## DEVIATION REQUEST AND DECISION FORM

Project Name : Homestead North at Sterling Ranch Filing No. 1

A deviation from the standards of or in Section **ECM section 2.5.2 Pedestrian Facilities** of the Engineering Criteria Manual (ECM) is requested for the Jane Kirkman / Texas Jack T Intersection accessible curb ramp layout.

**Figure 2-36. Access Ramp Locations at "T" Intersections**

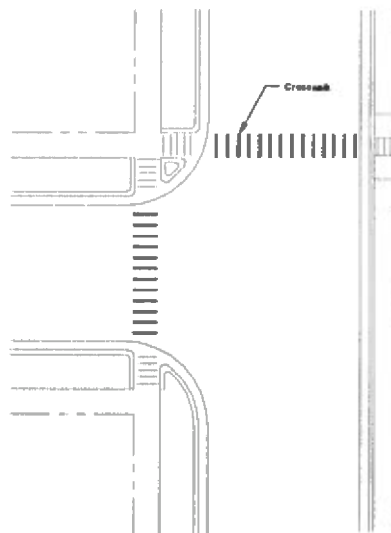
ECM Section 2.5.2.C.3 Accessible Curb Ramps at "T" intersections. All "T" intersections shall have a minimum of four curb ramps as shown in Figure 2-26 (Exhibit A)

The south flowline slope of Jane Kirkman will exceed the accessible ramp cross slope standard of 2%.

See Exhibit A for a sketch of the proposed accessible ramp layout of for Jane Kirkman Drive and Texas Jack Drive.

To accommodate accessible access from north to south, ramps and a crosswalk will be placed across Texas Jack both north and south of Jane Kirkman Drive. There is also an accessible ramp and crosswalk crossing Jane Kirkman approximately 200 feet west near Vollmer Road.

This request has been determined to have met the criteria for approval. A deviation from Section 2.5.2 of the ECM is hereby granted based on the justification provided.
